# Access Compliance Report

## Public Rights-of-Way

Intersection ID: 51721	Main Street: PROVIDENCE_RD_WEST	Cross Street: BALLANCROFT_PY	Location: NW
ADA ID: 5E18775A8B12	Ramp Type: BlendTrans1	Initial Pass/Fail: Fail	Overall Compliance: No
		Severity Score: 12.5

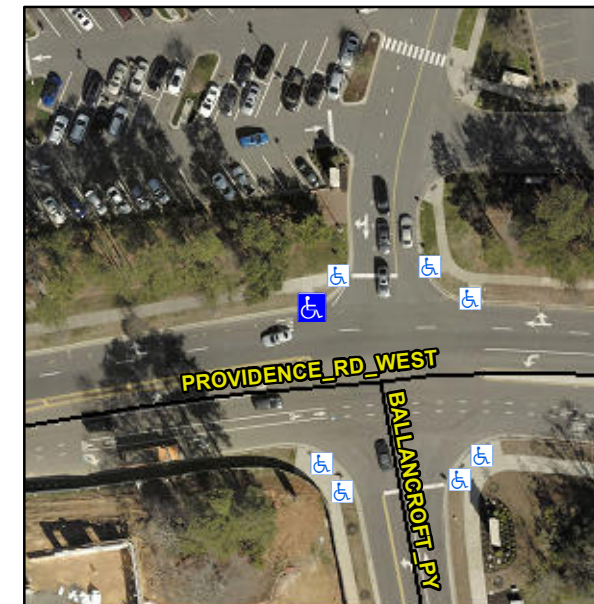
**Not Found, R304.5.3**

Compliance	Description	Data	Compliance	Description	Data
N/A	Ramp Length (in)	86.0	Yes	BlendTrans Slope (%)	4.5
Yes	Ramp Width (in)	71.0	No	BlendTrans XSlope (%)	6.5
N/A	Flare Type LT	N/A	N/A	Flare Type RT	N/A
N/A	Flare Slope LT (%)	N/A	N/A	Flare Slope RT (%)	N/A
N/A	Flare Traversable LT?	N/A	N/A	Flare Traversable RT?	N/A
N/A	Landing Length (in)	N/A	N/A	DWS Provided?	N/A
N/A	Landing Width (in)	N/A	N/A	DWS Contrast?	N/A
N/A	Landing Slope (%)	N/A	N/A	DWS Length (in)	N/A
N/A	Landing X Slope (%)	N/A	N/A	DWS Full Width?	N/A
N/A	Landing Curb? (Y/N)	N/A	N/A	DWS Offset (in)	N/A
N/A	Shared Landing?	N/A			
N/A	Gutter Ponding?	N/A	N/A	Gutter Slope (%)	N/A
N/A	Gutter Lip Ht (in)	N/A	N/A	Gutter X Slope (%)	N/A
N/A	Painted X Walk1?	No	N/A	Painted X Walk2?	N/A
	X Walk 1 Direction	To S		X Walk 2 Direction	N/A
	X Walk 1 Width (in)	N/A		X Walk 2 Width (in)	N/A
	X Walk 1 Slope (%)	4.2		X Walk 2 Slope (%)	N/A
	X Walk 1 X Slope (%)	4.1		X Walk 2 X Slope (%)	N/A

N/A	Ramp inside XWalk1?	N/A	N/A	Ramp inside XWalk2?	N/A
	Road Slope (%)	4.1		Clear Space?	N/A
	Road X Slope (%)	4.2	N/A	Clear Space to XWalk (in)	N/A
N/A	Any Obstructions?	N/A	N/A	Storm Grate/Utility Hazard?	N/A
	Obstruction Type			Storm Grate/Utility Type	
		N/A			N/A
			Yes	Surface Condition? (G/P)	Good
			No	Curb Slope (%)	5.7

**Remove & Replace Curb Ramp With Two New Directional Ramps or Equivalent.**
